Product Change Notice (PCN)

PCN Number: PCN-0380008R-01

Product(s) Affected: GF0779TV

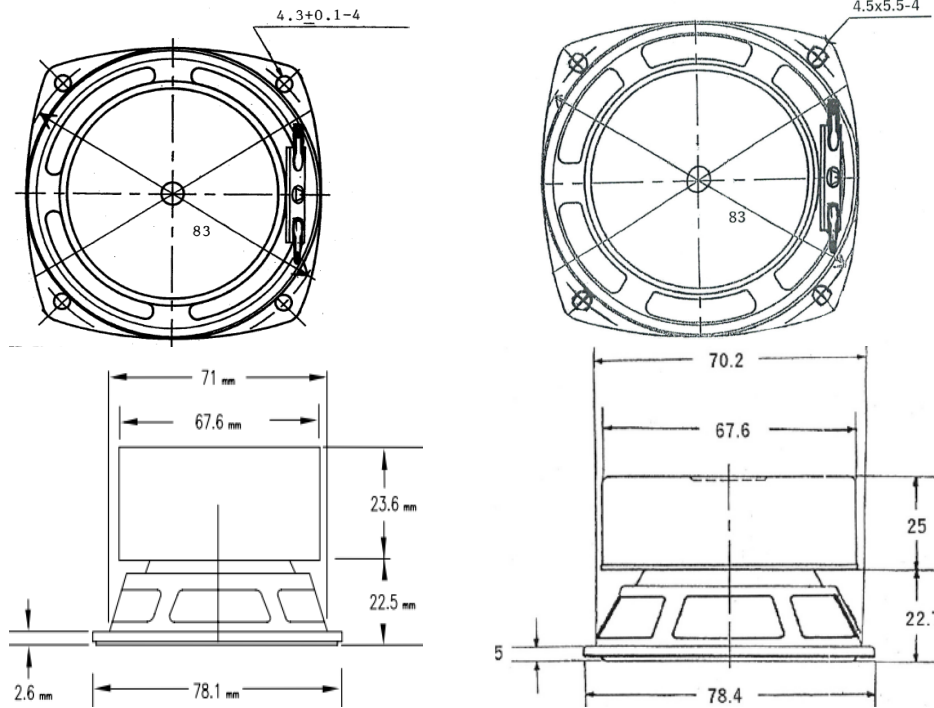
Description of Change: Metal frame altered creating a higher resonance frequency and SPL. The Buzz, Rattle, etc voltage has also been impacted and the screw terminal dimensions altered.

Previous Design:
 Resonant Frequency 125 Hz \pm 18 Hz
 SPL 89dB
 Buzz, Rattle, etc. 6 V

New Design:
 Resonant Frequency 150 Hz \pm 30 Hz
 SPL 94dB
 Buzz, Rattle, etc. 6.92 V

See drawings below for dimensional changes
